RESOLUTION NO. 2017-27

A RESOLUTION OF THE LOWER PROVIDENCE TOWNSHIP BOARD OF SUPERVISORS, MONTGOMERY COUNTY, PENNSYLVANIA, APPROVING THE PRELIMINARY/FINAL SUBDIVISION AND LAND DEVELOPMENT PLAN FOR LIDL US FOR A PROPOSED GROCERY STORE AT 2601-2614 RIDGE PIKE

RE: **Traffic Review #2 – Transportation Impact Study/Partial Plan Resubmission**
Proposed Lidl Discount Supermarket [Ridge Pike (SR 0363) and Trooper Rd (SR 3002)]
Lower Providence Township, Montgomery County
McMahon Project No. 817300.11

SUBJECT: REVIEW COMMENTS – LIDL US
SUBDIVISION AND LAND DEVELOPMENT PLAN DATED JULY 26, 2017; AND
REVISED SITE PLAN AND LANDSCAPE PLAN DATED SEPTEMBER 8, 2017

2.A Five (5) Rectangular Planters Near the Concrete Entrance Apron

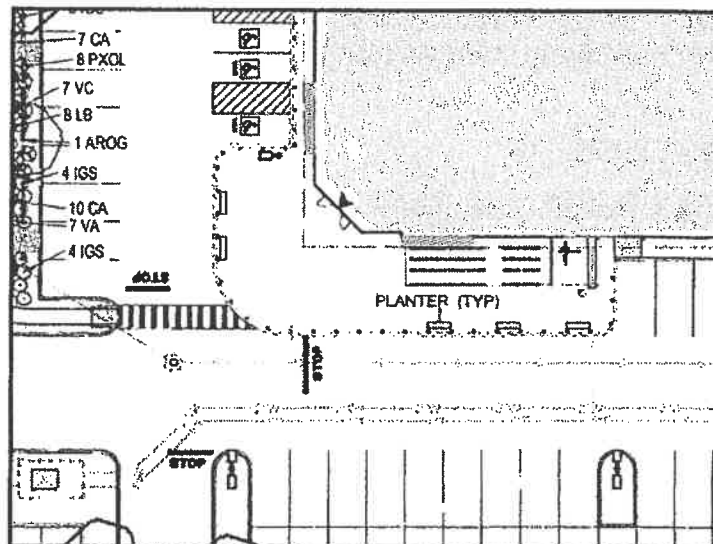
Five (5) low rectangular planters (approx. 1.5 feet wide x 6 feet long x 1.5 feet high) could be installed in the locations pictured below. They could be planted with low-maintenance ornamental grasses, such as Blue Fescue (*Festuca glauca*).

In addition to enhancing the appearance of the entrance area, we believe that such planters would help to channel pedestrian traffic between the entrance and parking spaces, thereby providing more visual predictability for motorists. On the other hand, we do not believe that such limited planter installation would degrade pedestrian convenience.

2.A Five (5) Rectangular Planters Near the Concrete Entrance Apron

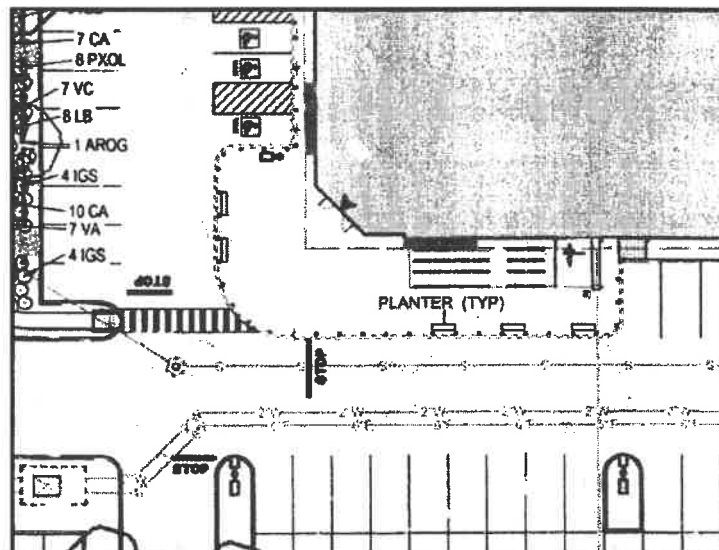
Five (5) low rectangular planters (approx. 1.5 feet wide x 6 feet long x 1.5 feet high) could be installed in the locations pictured below. They could be planted with low-maintenance ornamental grasses, such as Blue Fescue (*Festuca glauca*).

In addition to enhancing the appearance of the entrance area, we believe that such planters would help to channel pedestrian traffic between the entrance and parking spaces, thereby providing more visual predictability for motorists. On the other hand, we do not believe that such limited planter installation would degrade pedestrian convenience.
